Model	AD1	Volt/Hz	Date of Modification	Serial Number
Modified Article		No serial Number cut-in information		
Reason for Modification	Parts catalog correction

The following should be corrected. Please correct your part catalog.

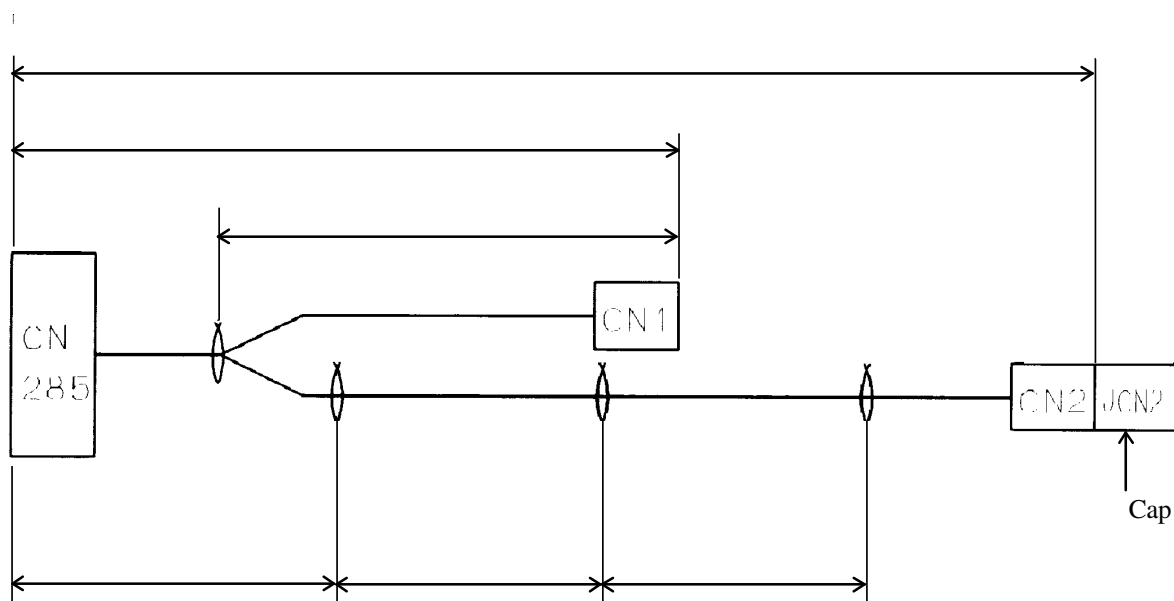
Old part number	New part number	Description	Qty	Int	Page	Index	Note
A1935459	A1935216	Harness - Fusing Lamp	1-1	O/O	44	20

The cap has been added to protect the connector for the heater.

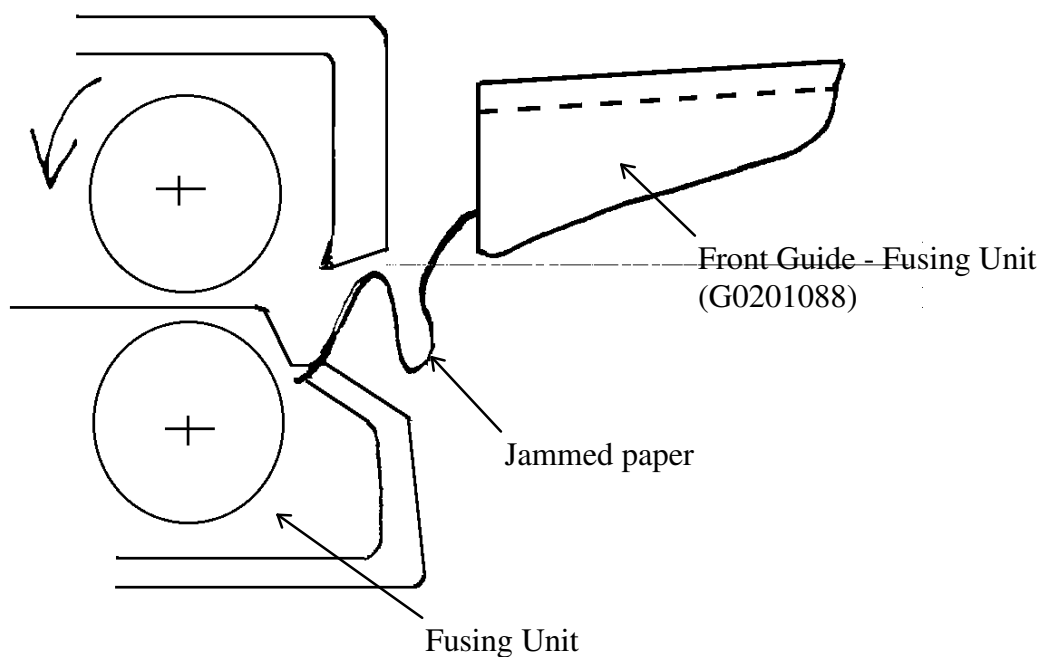
To prevent paper jams at the fusing unit entrance when the trailing edge contacts the Front Guide - Fusing Unit (G0201088), the front guide has been removed from February production '97.

Old part number	New part number	Description	Qty	Int	Page	Index	Note
G0201088		Front Guide-Fusing Unit	1-0		34	27

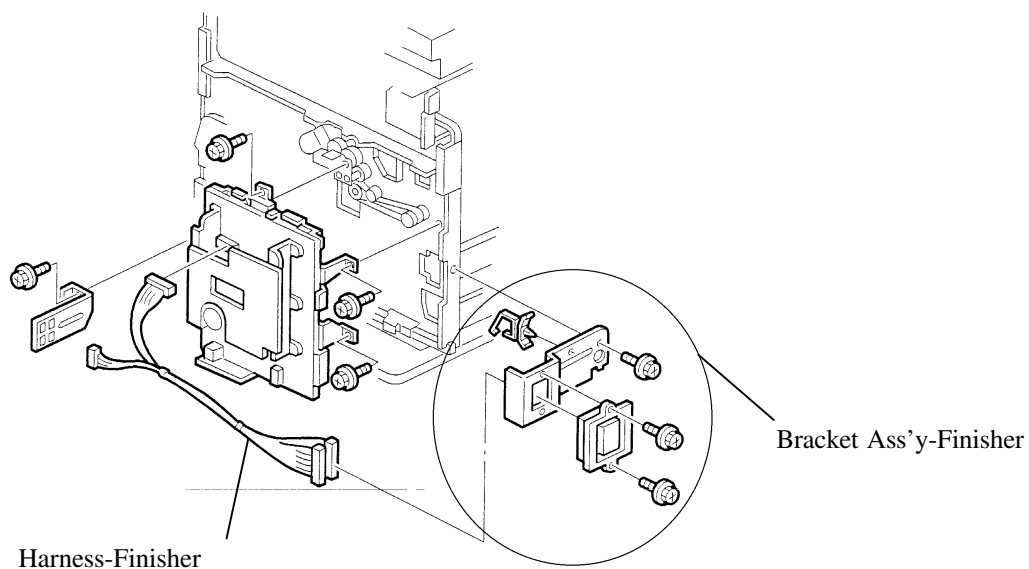
A harness and a bracket have been added for the Finisher (SR210) from December production '96.

Old part number	New part number	Description	Qty	Int	Page	Index	Note
A1931319	A2241319	Operation Decal	1-1	x/o	7	21	
A1931207	A2241207	Lower Left Cover	1-1	x/o	9	3	
11050344		Clamp	1-0		61	178	
	A1935497	Harness - Finisher	0-1				
	A1935819	Bracket A'ssy - Finisher	0-1

2. Exterior 2 (A193)

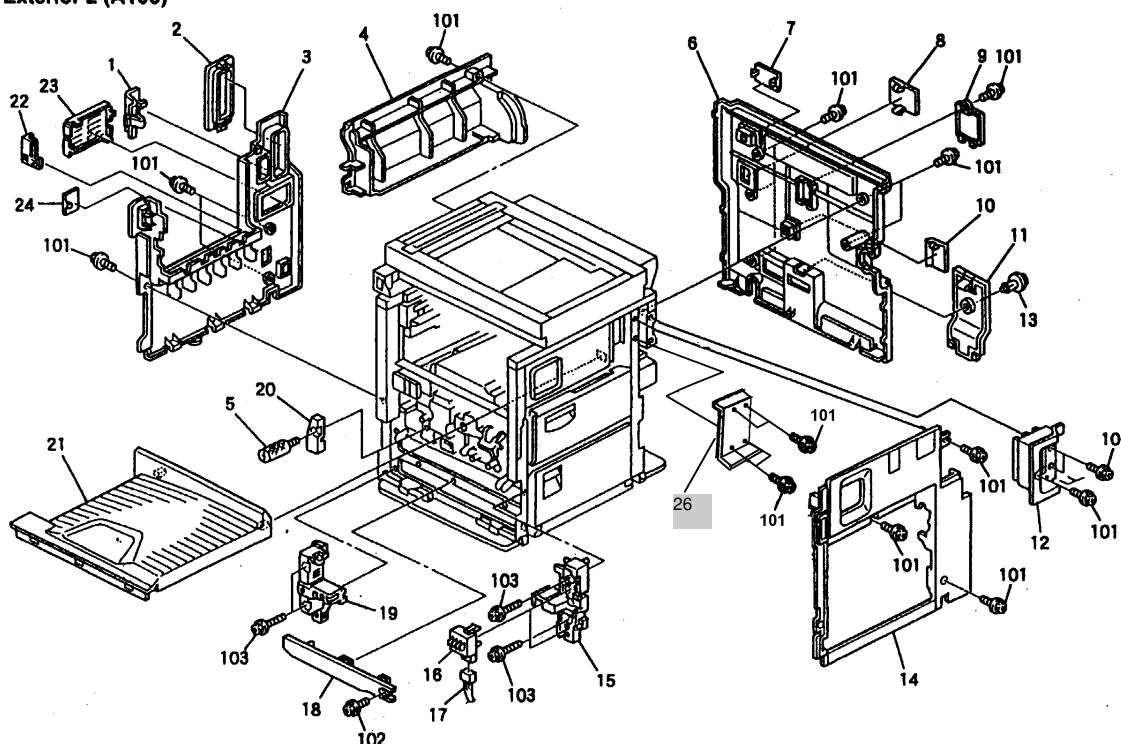
2. The part number for the Shield Plate (A1935826) is on page 61-index 182 but not the illustration for this part. So, the illustration and the parts list have been changed (refer to the attached illustration).

Old part number	New part number	Description	Qty	Int	Page	Index	Note
-	A1935826	Shield Plate	1	-	9	26

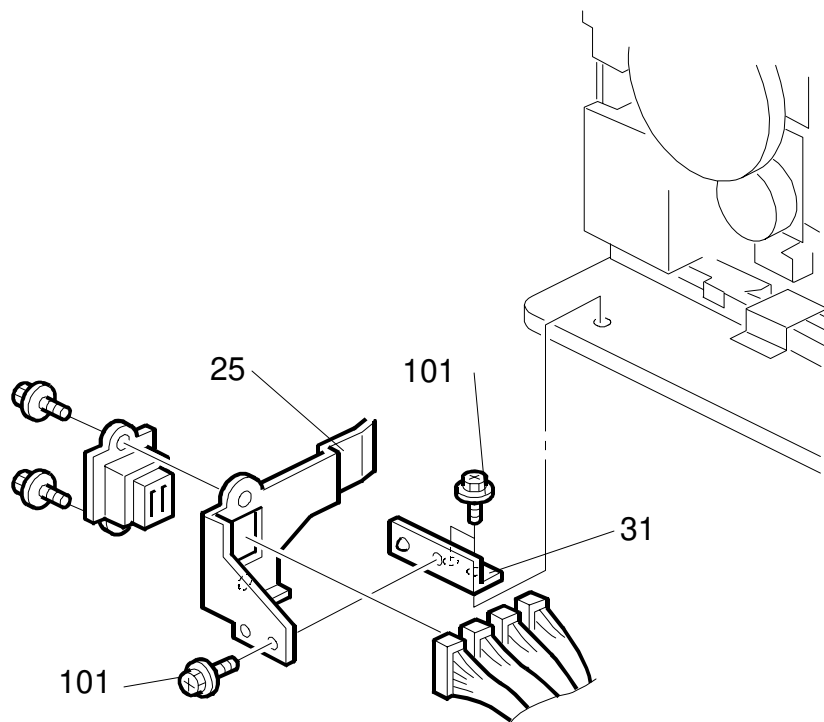
Old part number	New part number	Description	Qty	Int	Page	Index	Note
C2242867	C2252867	Decal - Key Top Cover (NRG)	1		7	24	
G0202722	G0202723	By-pass Feed Shaft	1		23	29	
	A2245821	Base Connector Bracket - LCT	1		53	31

6. Paper Tray (A193)

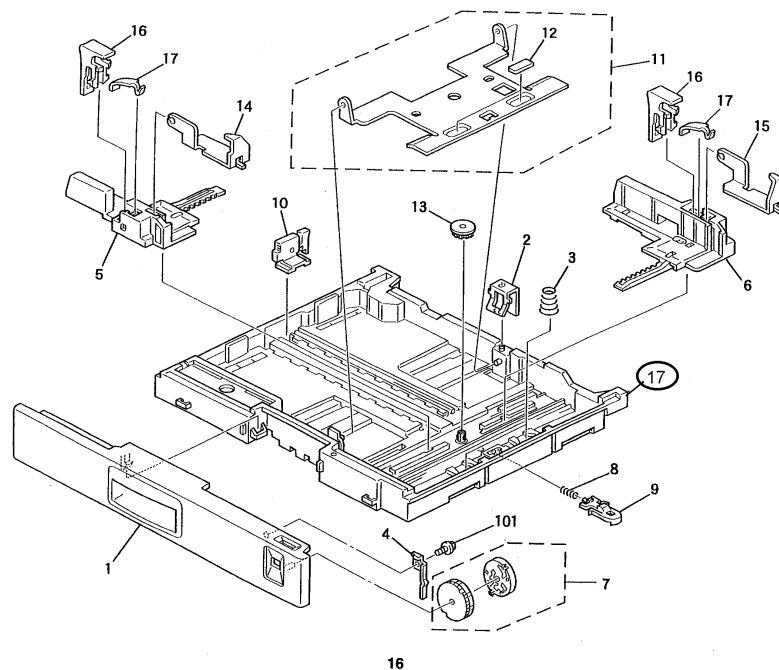
The following part is missing. Please correct your part catalog.

Old part number	New part number	Description	Qty	Int	Page	Index
	G0202590	Paper Tray Base	1		17	17

6. Paper Tray (A224)

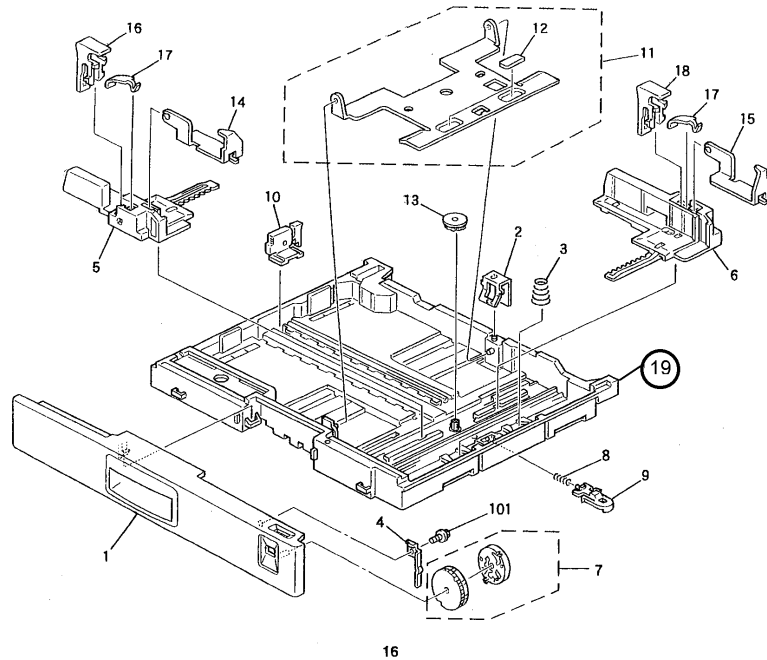
Old part number	New part number	Description	Qty	Int	Page	Index
	G0202590	Paper Tray Base	1		17	19

9. Optics Section 1(A193)

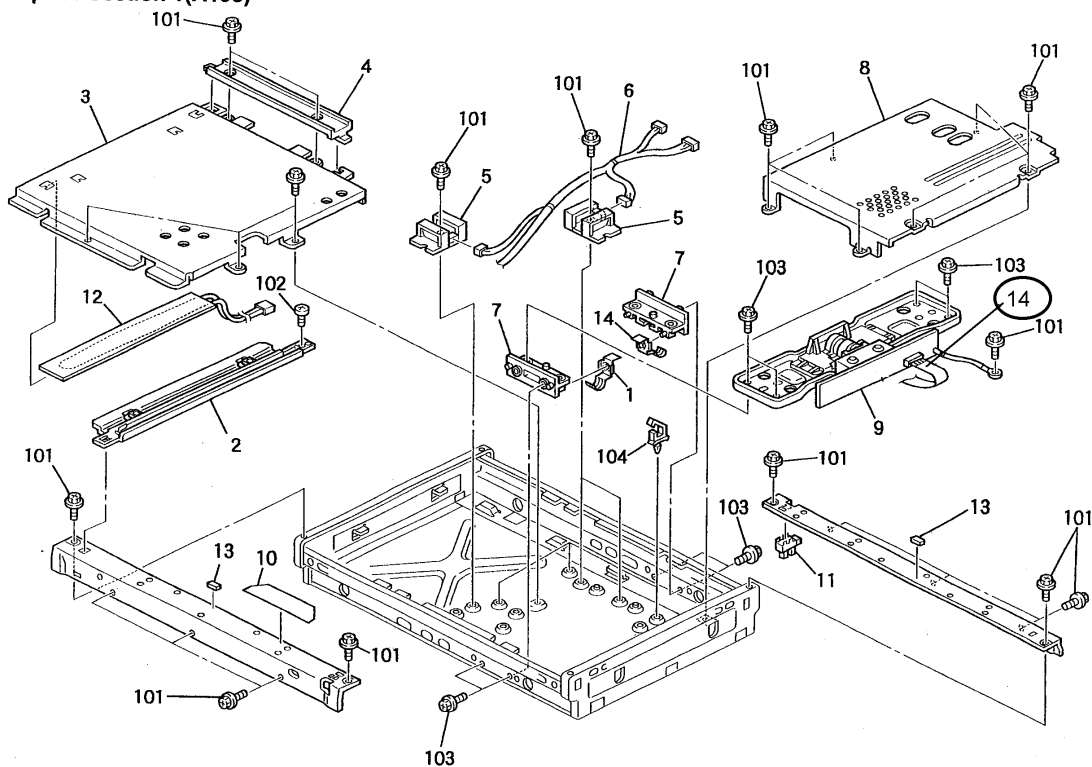
The following part number has been set up recently. Please correct your part catalog.

Old part number	New part number	Description	Qty	Int	Page	Index	Note
	A1935468	Harness – SBU	1		23	14

11.Optics Section 1 (A224)

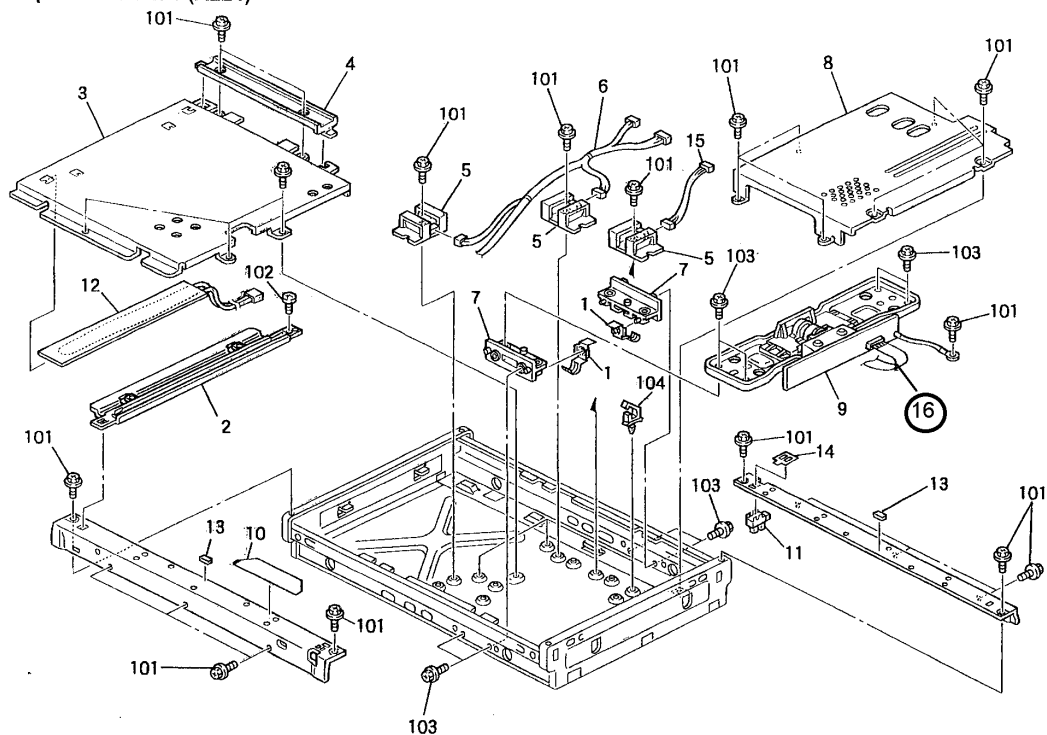
Old part number	New part number	Description	Qty	Int	Page	Index	Note
	A1935468	Harness – SBU	1		27	16

5.By-pass Feed Table (A193)

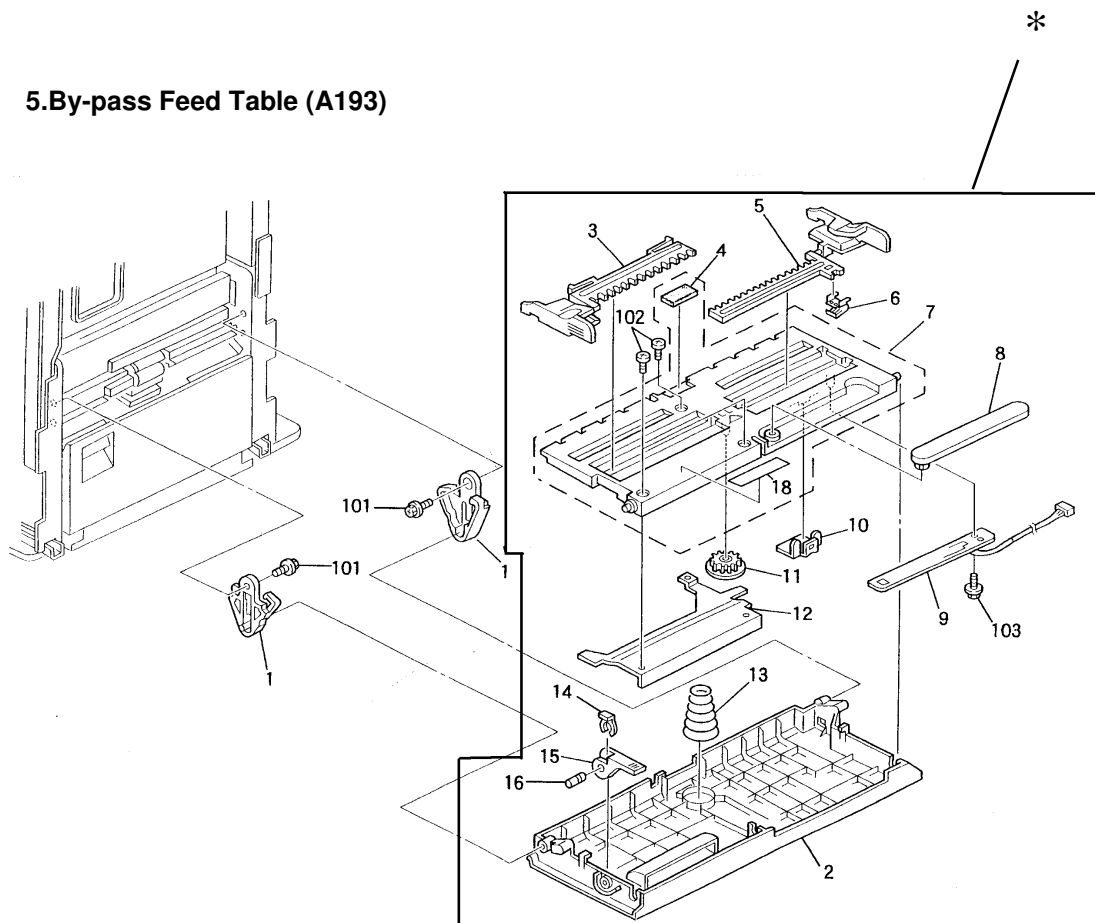
The assembly part number for the bypass tray has been set up to facilitate assembly.

Old P/N	New P/N	Description	Q'ty	Index No.	Page
	G0202700	Bypass Feed Table Ass'y	1	*	15

15. Paper Exit Section (A193)

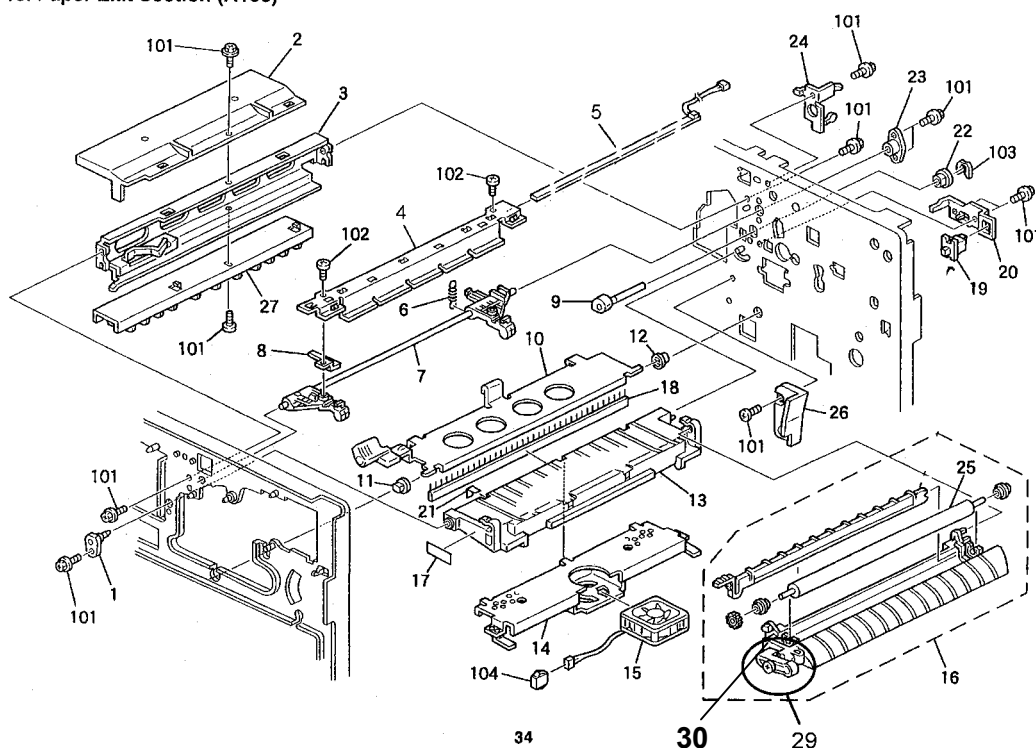
The part number for a spring of the lever has been newly set up.

The part number for the lever of the transfer and separation unit has been newly set up.

Old P/N	New P/N	Description	Q'ty	Index No.	Page
	G0203865	Lever – Transfer unit	1	29	35
	<i>G0203866</i>	<i>Spring – Lever</i>	<i>1</i>	<i>30</i>	<i>35</i>

12.Toner Hopper Unit (A193)

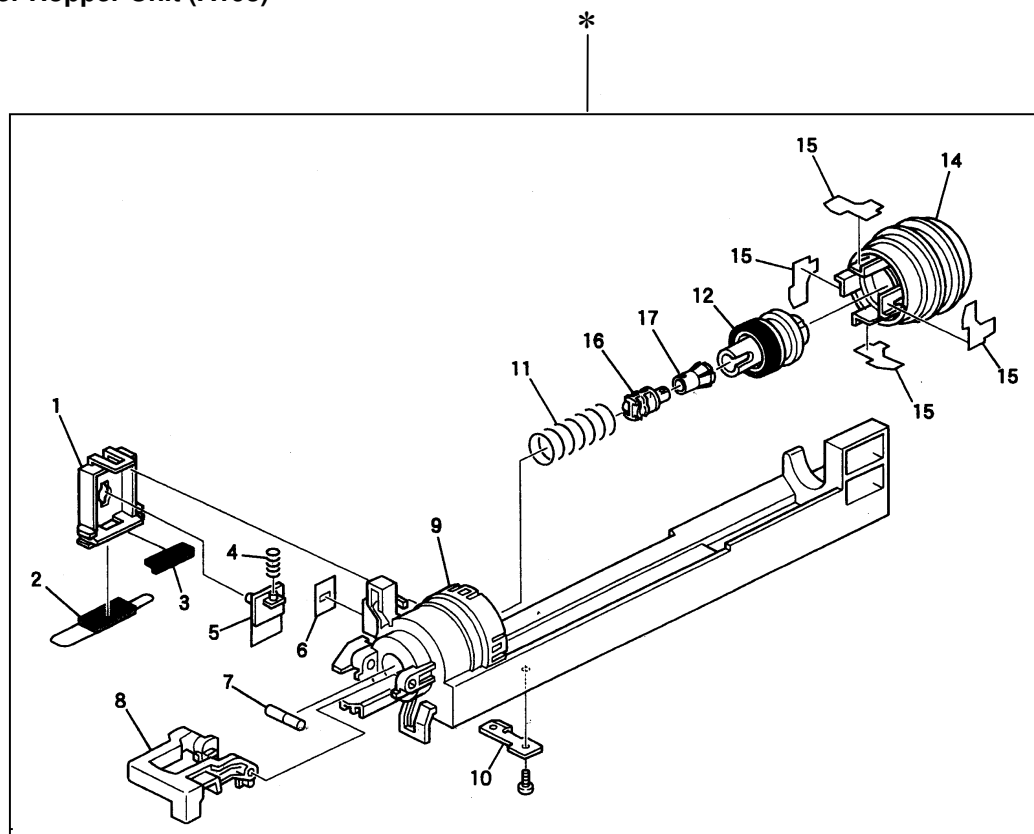
The part numbers for the toner hopper unit have just been set up.

Old P/N	New P/N	Description	Qty	Index No.	Page
	G0203030	Toner Hopper Unit – AD1	1	*	29

14.Toner Hopper Unit (A224)

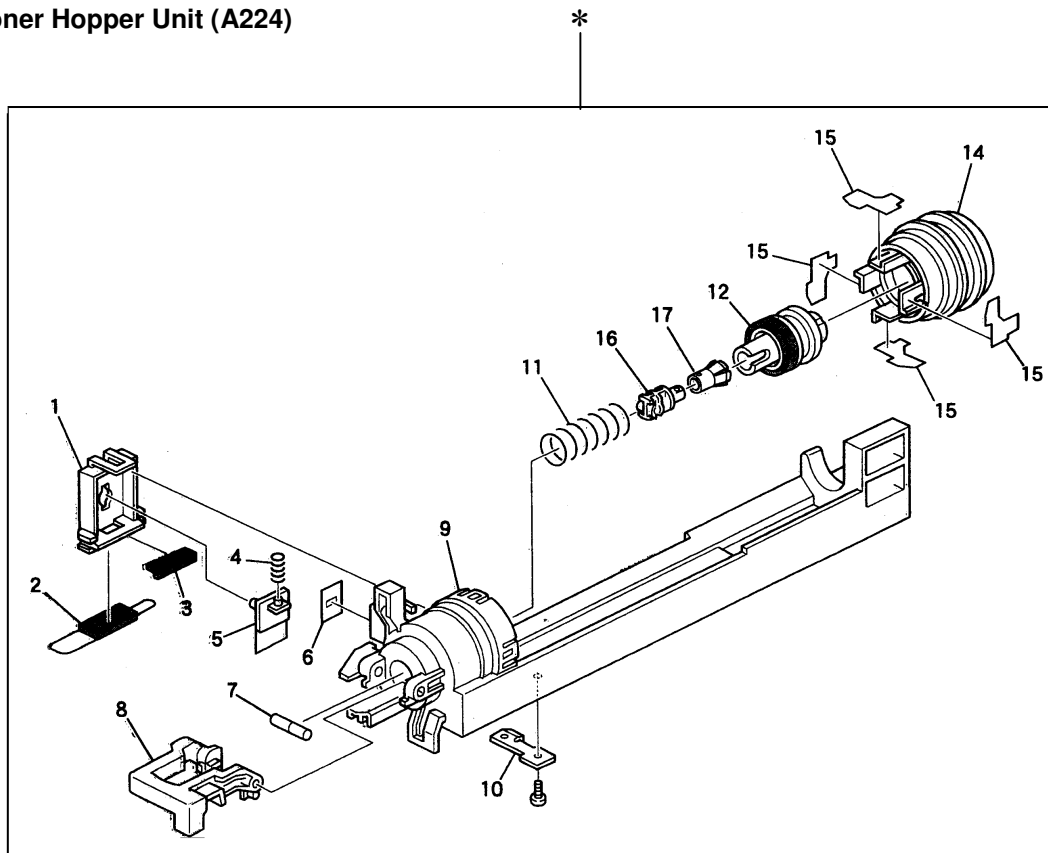
Old P/N	New P/N	Description	Qty	Index No.	Page
	A2243030	Toner Hopper Unit – AD1E	1	*	33

4.Operation Panel (A193/A224)

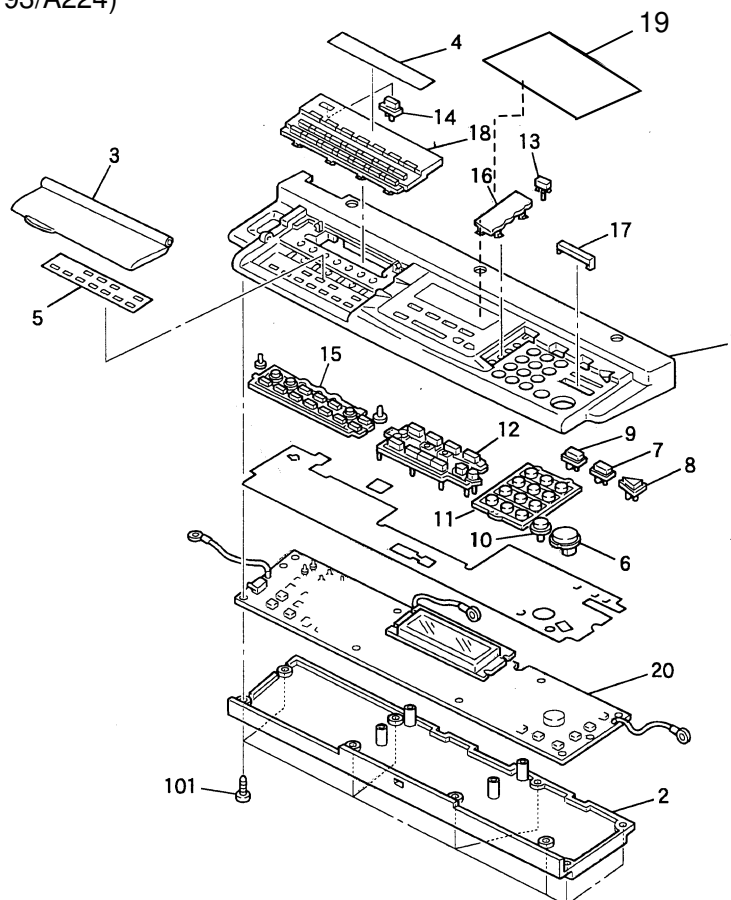
Part Number	Description	Qty	Int	Page	Index	Note
A1931460	LCD Panel (LT)	1		13	19	
A1931469	LCD Panel (A4)	1		13	19

Please also add to the following illustration on page 12 (Panel).

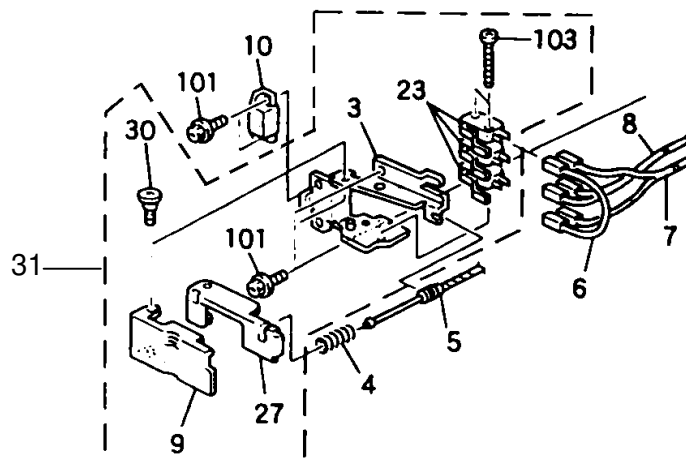
Old part number	New part number	Description	Qty	Int	Page	Index	Note
G0205810	G0205808	Bracket - Safety Switch			49	3	
G0205486	G0205807	Safety Switch Ass'y			49	31

Item10 (Magnet Clutch) is not included in Item 31 and the drawing is corrected as follows.
